*File -
movable
shelves
project*

Floor system revision - rough draft.

Chain guide channel + bumper strip

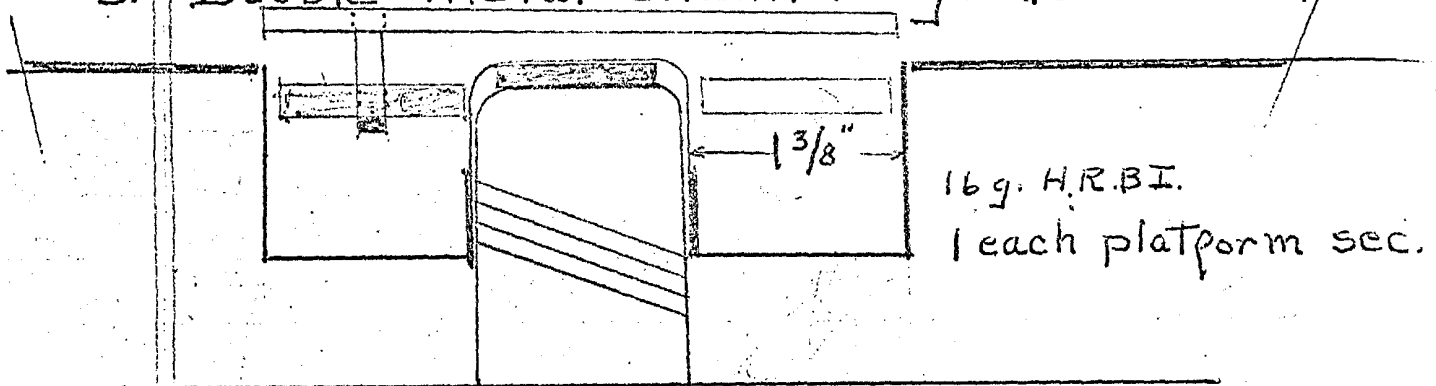
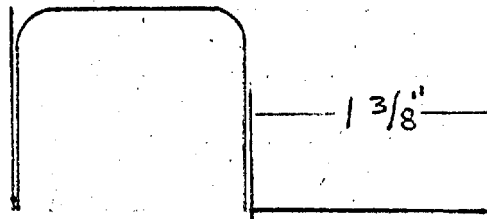
- 2. Chain guide channel + bumper strip
2 pcs. 32 lin. ft.

3. Double metal channels - guide wheels,

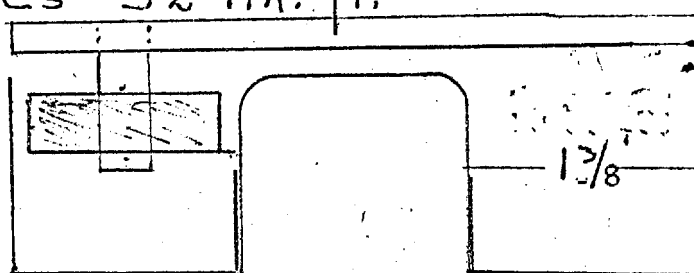
- 3. Double metal channels for guide wheels.
2 pcs - 32 lin. ft.
